Your Reference
LAHC 2020/642
PO 4100016970

Response to Submissions: Water Quality & Stormwater Addendum

The Riverwood Estate Planning Proposal was placed on public exhibition between 12 August and 25 September 2022.

Figure 9 Flood Evacuation Map

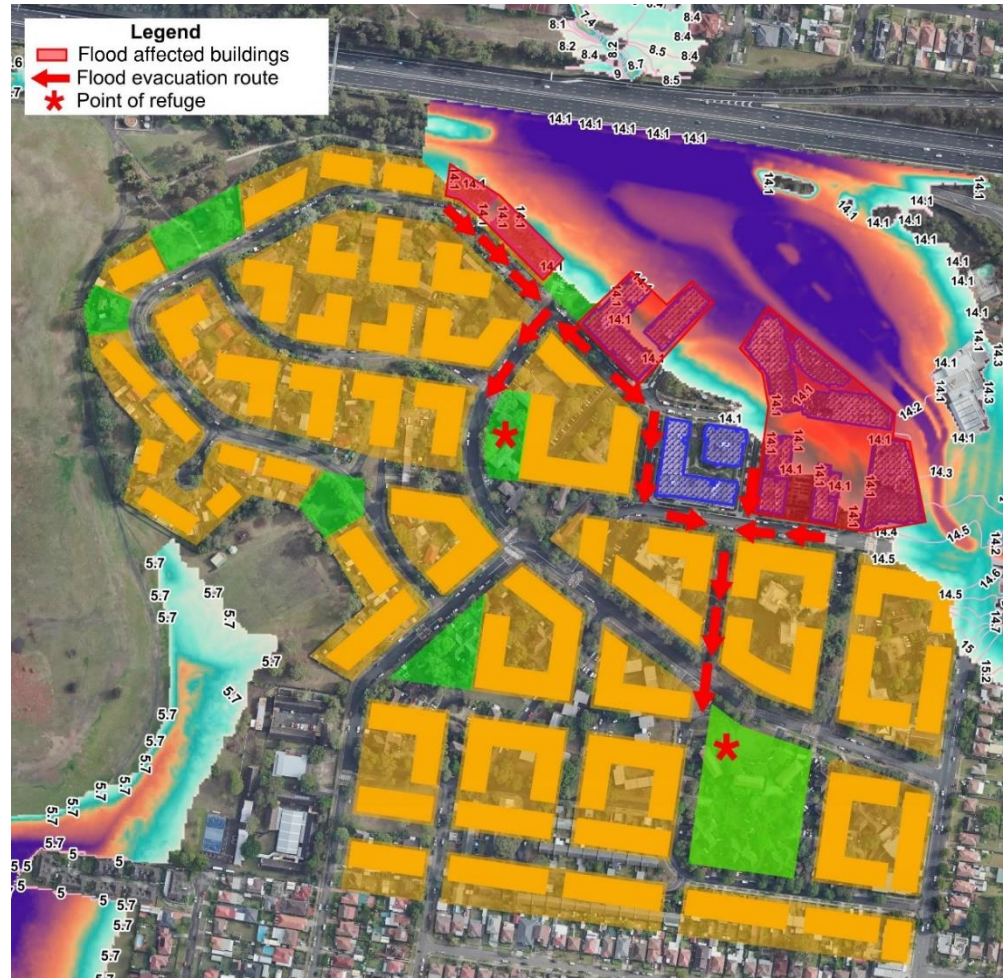
The proponent states that the "evacuation procedure will be managed through building management with appropriate warning systems". EHG recommends any evacuation, shelter-in-place, and site-specific emergency management plans to mitigate potential risks to residents, visitors, and workers of the proposed developments under major and extreme flooding events should be referred to the NSW State Emergency Service (SES) and Canterbury-Bankstown Council for comment prior to its adoption.

Development strategies relying on deliberate isolation or sheltering in buildings surrounded by flood water are not equivalent, in risk management terms, to evacuation. 'Shelter in place' strategy is not an endorsed flood management strategy by the NSW SES for future development.

We agree that emergency management plans should be referred to SES for comment and approval as part of any development application. Developments may be safe for "shelter-in-place" strategies subject to the scale, form and orientation of the buildings, hazard exposure and availability of logical clear escape routes. This would be determined on a case-by-case basis through the development approval framework.

Figure 10 - OSD Only Catchment (Blue)

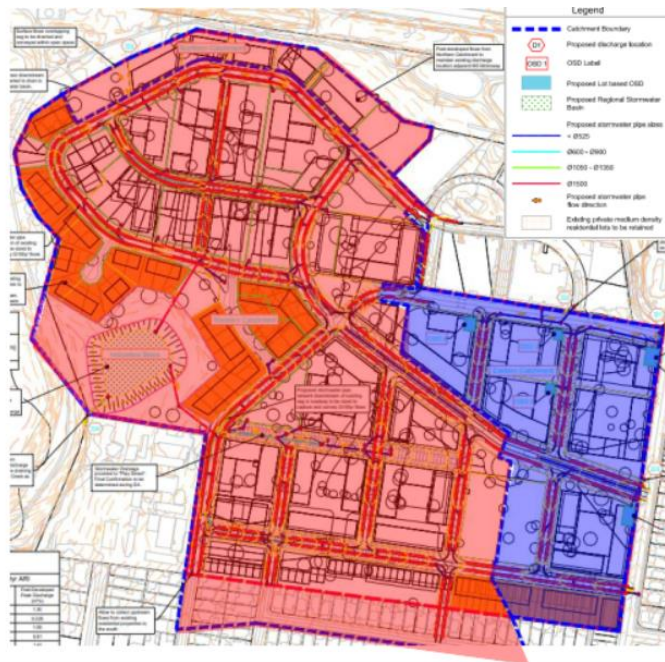
LAHC provide indicative feasibility comparison for on-site versus regional detention systems, and indicative annual maintenance costs of the proposed wetland in Kentucky Road Reserve, and demonstrate how individual sites will be capable of meeting stormwater management requirements.

It is noted that the revised rezoning extent sits completely in an area planned to be serviced via on-lot OSD. It would not be viable to utilise the wetland for this portion of the catchment. As such the individual site is capable of meeting its stormwater management requirements without the use of the reserve.
